APPEAL SUMMARY

Appeal ID: 16161	Project Address: 7176 N Vancouver Ave
Hearing Date: 11/22/17	Appellant Name: Tom Jaleski
Case No.: B-012	Appellant Phone: 5034885651
Appeal Type: Building	Plans Examiner/Inspector: Tara Carlson
Project Type: residential	Stories: 3 Occupancy: Townhouses Construction Type: V-B
Building/Business Name:	Fire Sprinklers: No
Appeal Involves: Erection of a new structure	LUR or Permit Application No.: 17-237864-CO
Plan Submitted Option: pdf [File 1]	Proposed use: Townhouses

APPEAL DECISION

ORIGAMI

SITE PLAN

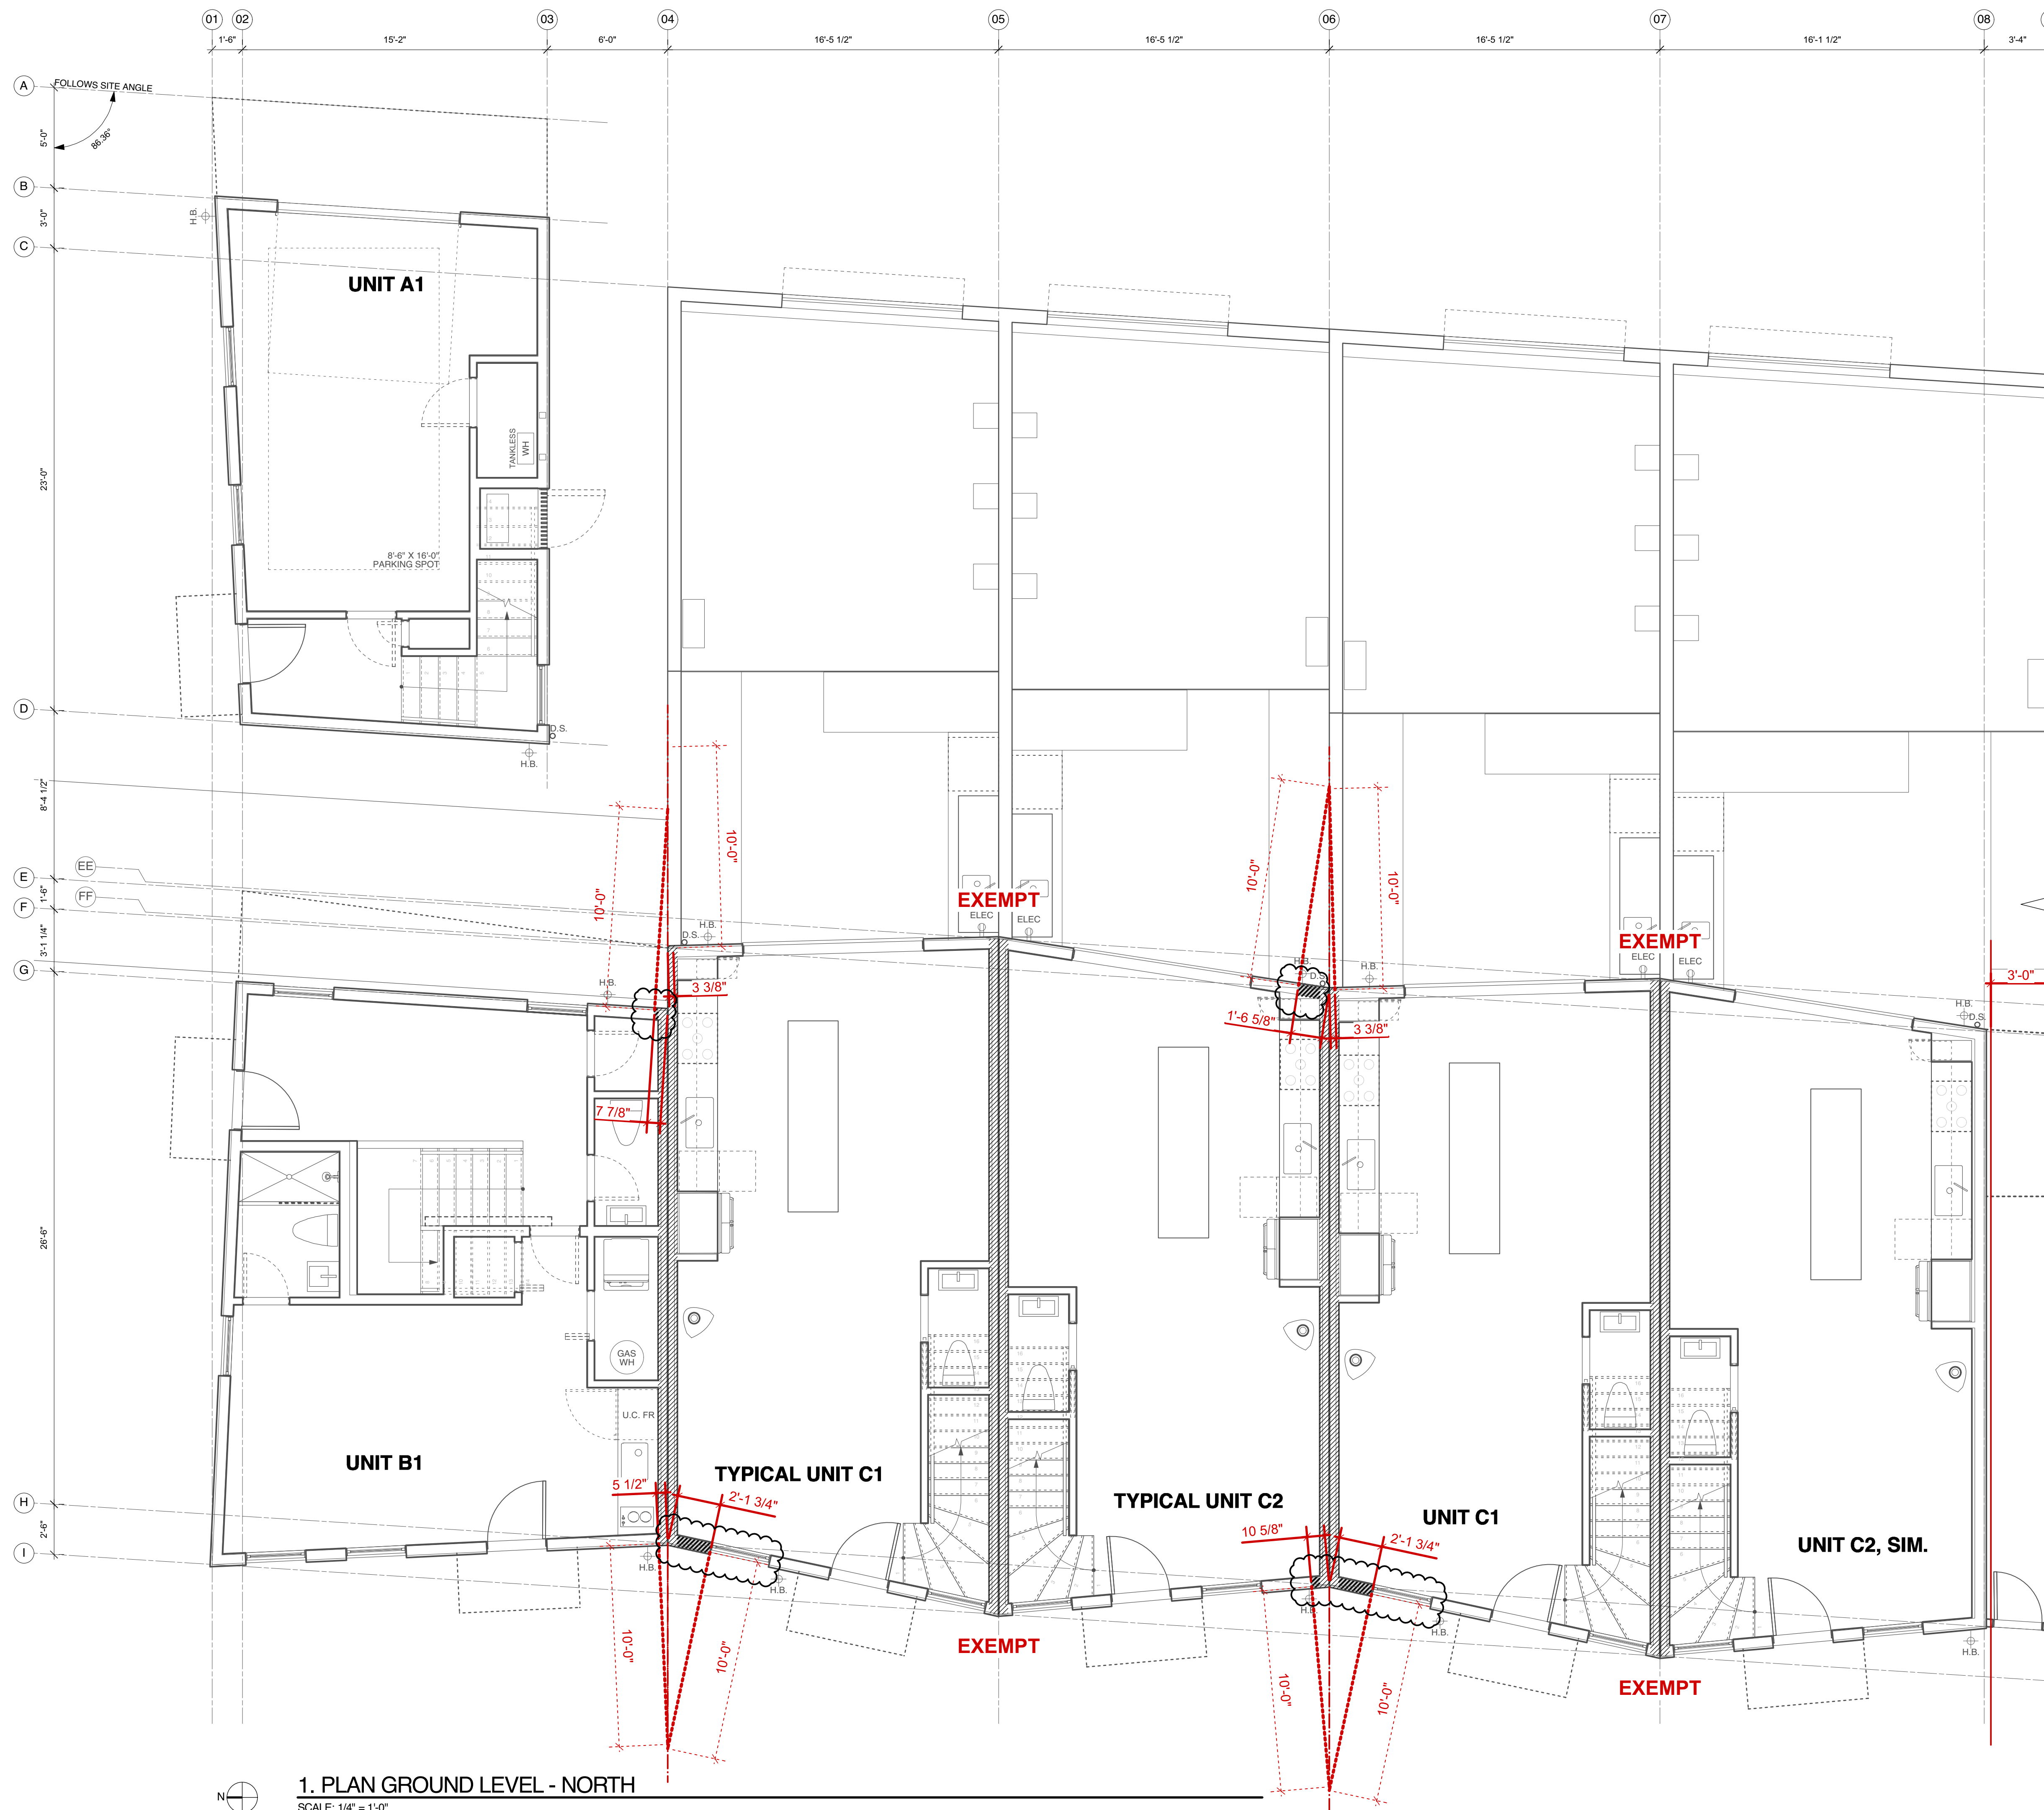
Proposed Design The proposed design for lots 2, 3, 4, 5, 7, 8, 9,10, and 12 of the Origami Townhouses where windows on the exterior walls are less than 3 feet from the common property line and the walls are less than perpendicular to the common property line are as follows:
The fixed windows will have a fire separation distance of at least 10 feet to the common property line, exceeding the requirement of Table R302.1.
The walls within 3 feet on either side of the common property line will have a 1 hour rated assembly with non-combustible siding.

The proposed design is to provide 1 hour rated walls with non-combustible siding on the exterior walls and have the windows located so that the fire separation distance to the common property line is at least 10 feet. 2014 ORSC Table R302.1 allows unlimited quantity of unprotected windows where the fire separation distance is only 3 feet, much less than our proposed design. The walls where the windows are located have angles less than perpendicular, but greater than 70 degrees, and allows windows near the common property lines to have a fire separation distance of 10 feet to the common property line. The fire separation distance is defined in R202 as the distance from the building face at a right angle, to the closest lot line. The fire separation distance of the windows in the proposed design, as shown on the attached plans, is at least 10 feet from the edge of the window closest to the common property line. The exterior walls are 1 hour rated exterior wall assemblies as required per R302.2.6.1 with the additional protection of non-combustible siding. These assemblies will mitigate the potential for fire and smoke spread between townhouses. ORSC R302.2.6 and R302.2.7 are meant to prevent the spread of fire and smoke between townhouses where the walls are less than 90 degrees to the common property line. These code sections do not address the varying degrees of wall angle to the common property line. The code section is roughly based on testing by NIST in Technical Note 1600, attached, where parallel walls are tested with a fire separation distance of 3 feet. The openings in the test are directly in line with each other and the test shows that the window in the adjacent unit did not break until the temperature reached 1000 degrees Fahrenheit (560 C). The openings in the proposed design are oriented less than 15 degrees from perpendicular to the common property line and provide additional protection against the migration of fire and smoke between windows by having a fire separation distance of at least 10 feet. Table R302.1 allows unprotected openings with a fire separation distance of more than 3 feet. This is consistent with the NIST test where it showed that windows lined up and 6 feet from each other. The proposed design greatly exceeds the tested conditions in relation to angle between the openings and fire separation distance. The additional protection measure provided of fire separation distances of at least 10 feet, greatly exceeds the requirements of R302.1 and provides equivalent protection for the openings to not be impacted by a fire/smoke event in an adjacent townhouse.

Measurement of fire separation distance where wall openings are not perpendicular to the common property line: Granted as proposed with one hour exterior walls rated for exposure to fire from the inside and non combustibile siding.
